ULNRC-04522

**DOCKET NUMBER 50-483
CALLAWAY PLANT
UNION ELECTRIC COMPANY
CHANGES TO THE NRC APPROVED FIRE PROTECTION PROGRAM**

ATTACHMENT 2

DESCRIPTION AND ASSESSMENT

Figure 1

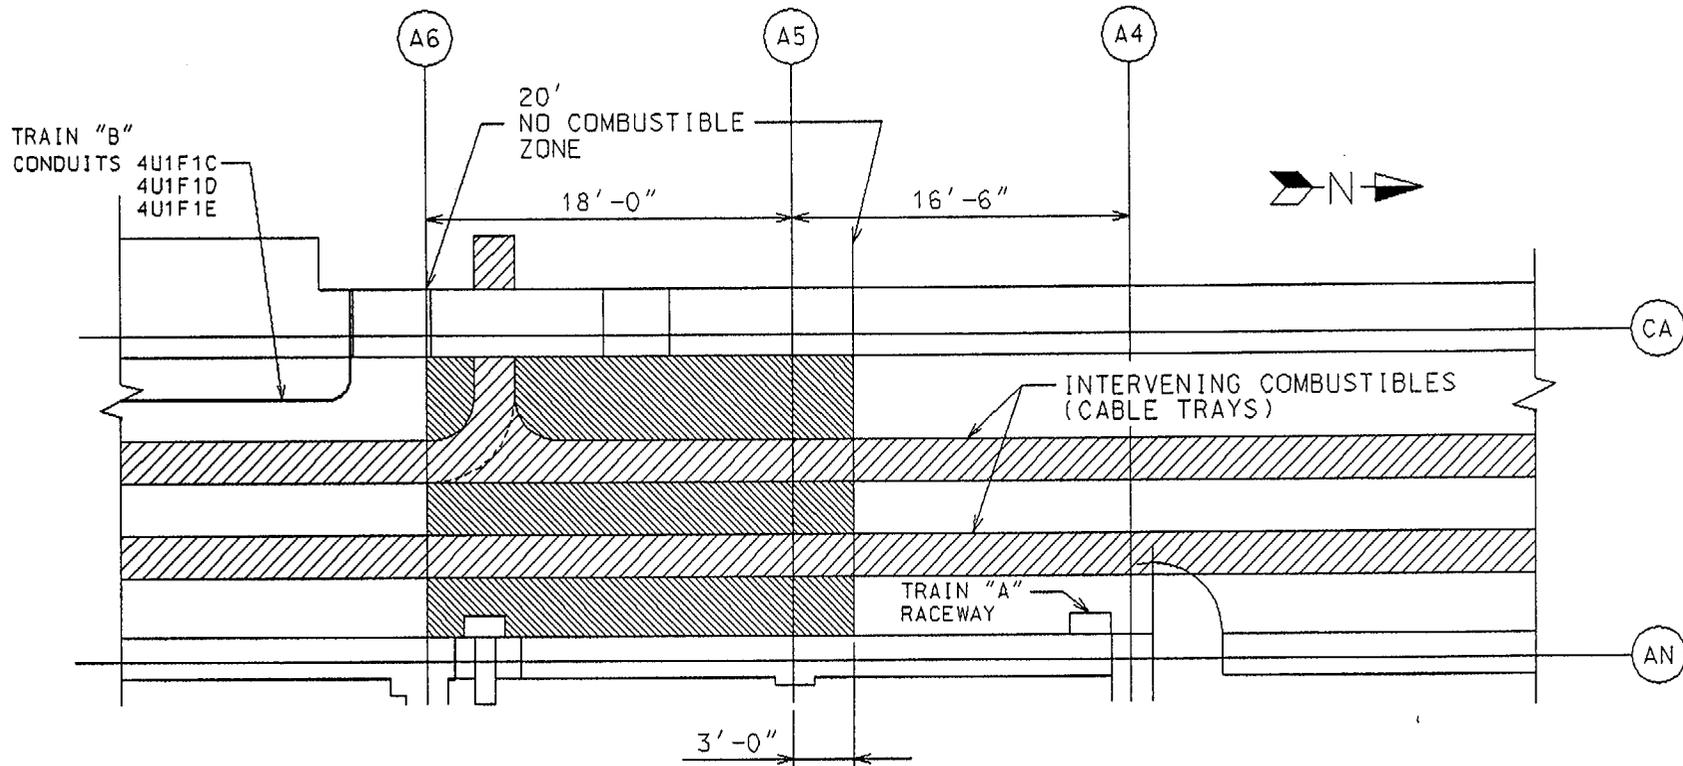
The cable trays located in the "No Combustible Zone" are non-safety related cables. There are two sets of horizontal cable trays in the area, see Figure 1. These two sets of cable tray are separated by approximately 3 feet. The set to the west side of the room is located four feet from the west wall and consists of 3 horizontally stacked trays. The bottom two trays coming from the north are enclosed with metal tray covers for more than 50 feet leading up to the separation zone. The top tray in this set has a metal tray cover within a portion of the 20-foot separation zone. The other cable tray set contains three horizontally stacked trays, which are located approximately three feet from the east wall. A 12-foot section of these trays is covered in the immediate vicinity of the "A" train raceway. These cable trays are also covered at the south end of the 20-foot separation zone for 40 feet in the south direction. The cable in both set of cable trays is IEEE-383 rated cable. The west cable trays pass approximately 1 foot from the conduit that contains cables associated with "B" Train component cooling water.

Although cable trays do traverse the 20 foot wide marked "No Combustible Zone", metal tray covers are installed on the trays in compliance with Regulatory Guide 1.75. The tray covers are designed to prevent ignition from exposure fires. The only credible fire in this area is from transient combustibles and the fire would have to propagate along the cable trays that contain IEEE-383 cables. The fire would have to sustain itself in the IEEE-383 cables because no transient combustibles would be located under the cable trays for the 20 foot wide "No Combustible Zone. It is not credible for a fire to propagate along the cable trays without additional combustible loading below the trays to sustain the fire in the trays. It should be noted lab tests that have determined that IEEE-383 cables will burn, contained a fuel source other than the cables. This fire would have to travel for 35 feet and then jump from cable trays that are covered with metal tray covers over into a conduit that is a horizontal distance of 1 foot away. Other than the cable

This paragraph will be clarified to state, " Redundant trains of centrifugal charging are located in Room 1101. One of the redundant trains of centrifugal charging is assured for hot shutdown in the event of a fire in this area. These redundant trains are separated by a horizontal distance of greater than 35 feet. Cable trays do traverse through the separation zone. However due to the fire resistance of the IEEE-383 cables in conjunction with the installed fire protection features of this area that include automatic detection and suppression, a fire propagating across the 20 foot separation zone is not considered credible."

Figure 2

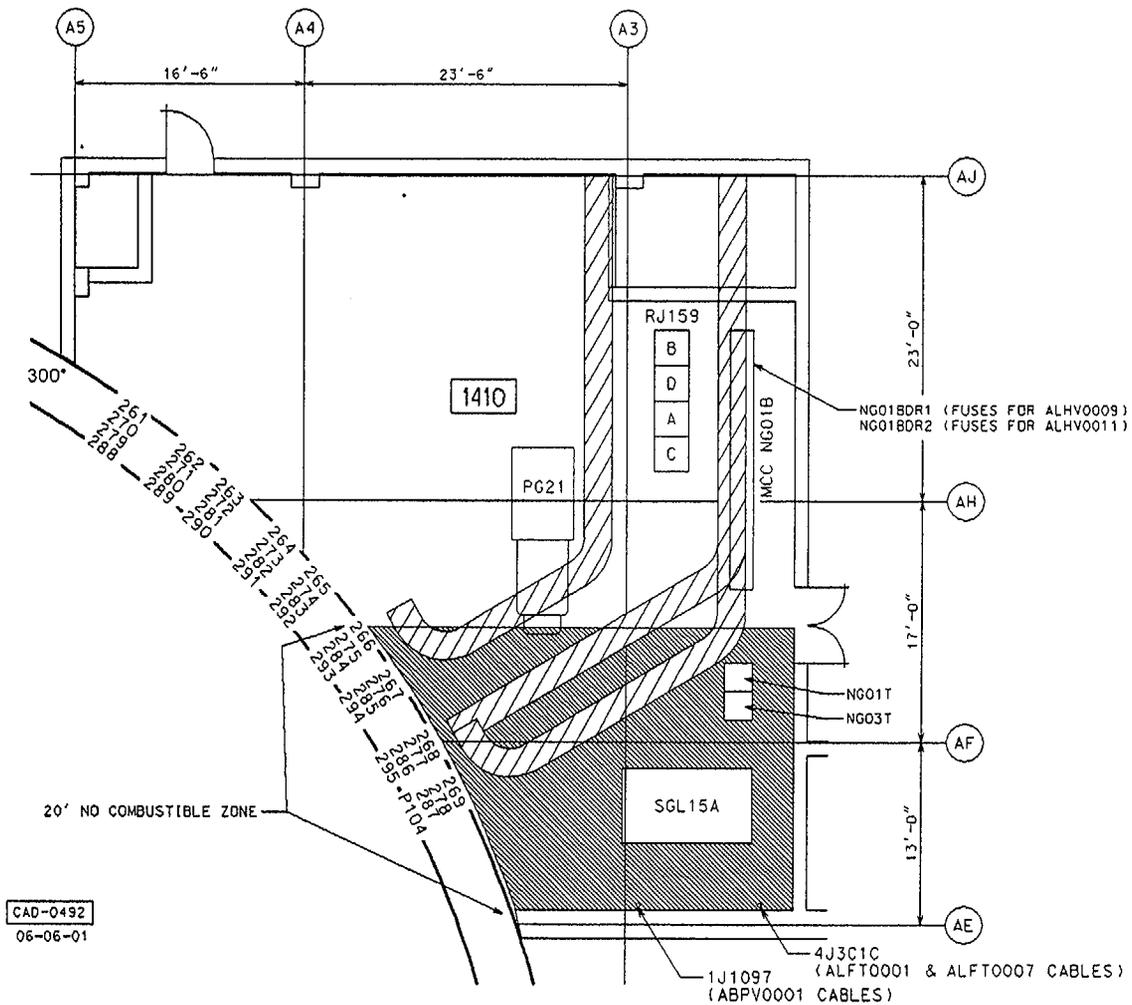
There are cable trays located within the area marked as the "No Combustible Zone". These cable trays contain non-safety related IEEE-383 cables. There are 3 sets of horizontally stacked trays. The trays closest to the "B" Train cables are more than 10 feet from the cables. Motor Control Center (MCC) NG01T and NG03T are also located within the separation zone. The MCCs are enclosed in metal cabinets and are located approximately 12 feet from conduit 4J3C1C. The room cooler is located approximately 4 feet from conduits 4J3C1C and 1J1097. The room cooler contains minimal combustible material.

Although cable trays do traverse the 20 foot wide marked "No Combustible Zone", there are no continuous runs of cable trays from the separated components that are greater than 20 feet apart. It is not credible for a fire to propagate from one side of the separation area to the other side based on the total quantity of combustibles located in the room. Fire would have to traverse from one cable tray and ignite cable within a conduit at a distance greater than 10 feet away.

This section will be revised by adding the following statement, "There are several cable trays, motor control centers, and the room cooler which traverse the 20 foot separation zone. However due to the fire resistance of the IEEE-383 cables in conjunction with the installed fire protection features of this area, a fire propagating across the 20 foot separation zone is not considered credible."
